REMEDIAL DESIGN REPORT ADDENDUM

**REYNOLDS CAN PLANT SITE
FULTON, NEW YORK**

**NEW YORK STATE DEPARTMENT OF ENVIRONMENTAL CONSERVATION
Division of Hazardous Waste Remediation
50 Wolf Road
Albany, New York 12233-7010**

DRAWING TITLE:	PROCESS FLOW DIAGRAM
DRAWN BY:	PAULO N. AMADO
CHECKED BY:	DAVID J. RUSSELL, P.E.
SCALE:	NO SCALE
DATE:	8/21/95
PROJECT NO.	957961
DRAWING NO.	2 - 1

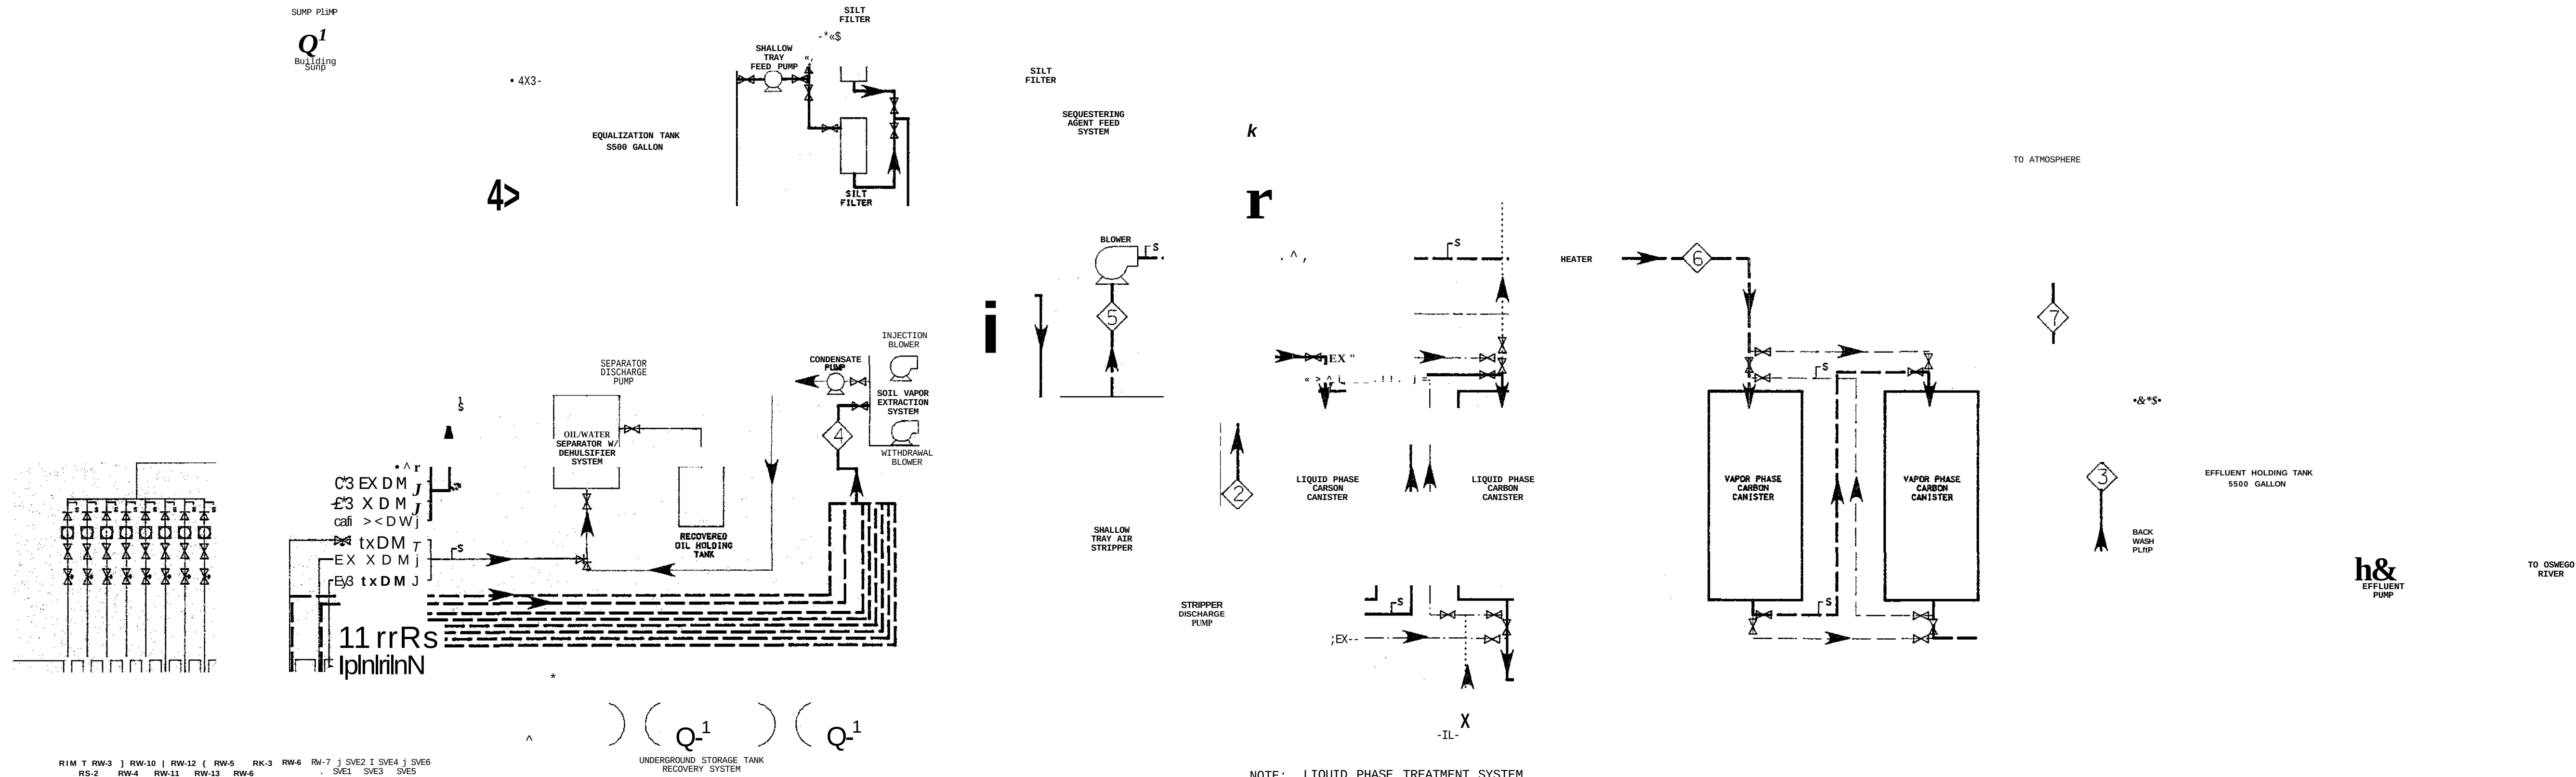
The design criteria of the groundwater treatment system to be installed will comply with the Remedial Design Report with an alternative approach concerning secondary treatment of the air stripper effluent stream. Due to the potential for ketones to be present in the air stripper effluent stream, the performance of the liquid phase activated carbon will be evaluated during the initial startup period. The groundwater treatment system will be installed with liquid phase activated carbon as the secondary treatment system. Upon start-up of the system a determination of the actual recovered concentrations and types of ketones will be made. Current groundwater monitoring data indicates that the ketone compounds are limited to the recovery wells currently present in the southern operable unit proposed recovery wells (RW-6 and RW-7).

The detailed design will include an effluent holding tank which was not included in the original Remedial Design Report. This effluent holding tank will provide a collection system to be used for potential required backwashing of the liquid phase activated carbon system and as a holding tank for discharge of the effluent to the discharge pipe. A discharge pump will be included with the holding tank to pump the effluent to the discharge pipe which will discharge the effluent to the Oswego River. A separate backwash pump system will also be installed to provide backwashing of the liquid phase activated carbon using the treated effluent, if needed. The resultant backwash water will be directed to the equalization tank and filtration system for processing through the treatment system.

NOTE: LIQUID PHASE TREATMENT SYSTEM SELECTED FOR INITIAL STARTUP STUDY. ALTERNATIVE SYSTEM MAY BE SUBSTITUTED BASED UPON RESULTS OF INITIAL STARTUP STUDY.

TITLE:
SOIL VAPOR EXTRACTION
SYSTEM

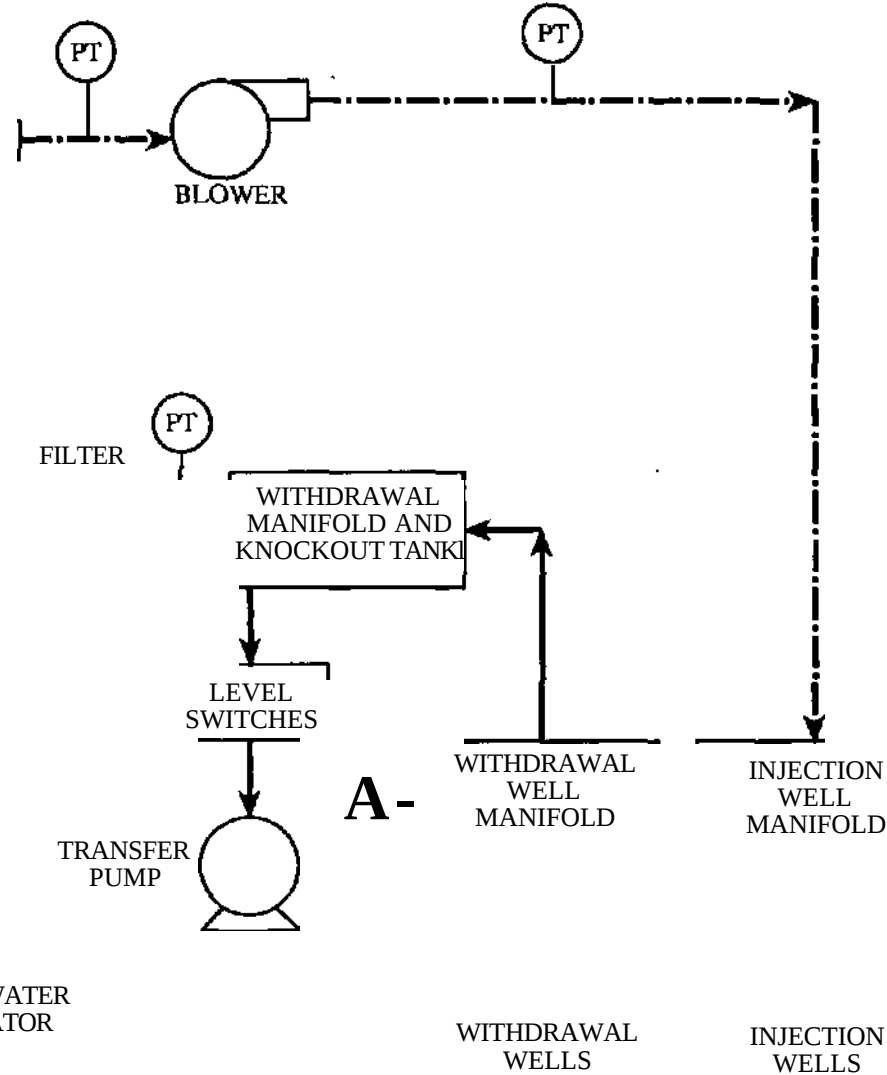
The SVE system to be designed and implemented will be an injection/withdrawal SVE system. This alternative was selected due to the following reasons.

Figure 2-3 presents a SVE schematic showing the major components of the proposed injection/withdrawal system. The injection/withdrawal system will include an extraction blower and injection blower that will provide the required vacuum and injection air flow.

The eight (8) SVE wells will be piped separately to the treatment system building allowing individual control of the operation of each individual well. This design will allow total control of each individual SVE well including use of all wells as either withdrawal or injection. This approach will also allow air flow and pressure measurements to be collected from each well, as well as collection of individual air samples. Based upon the operating results of the system, well parameters can be altered to ensure that the entire soil volume receives adequate treatment. The selected SVE system design will provide maximum flexibility in the operation of the system optimizing the overall remediation of the contaminated soils.
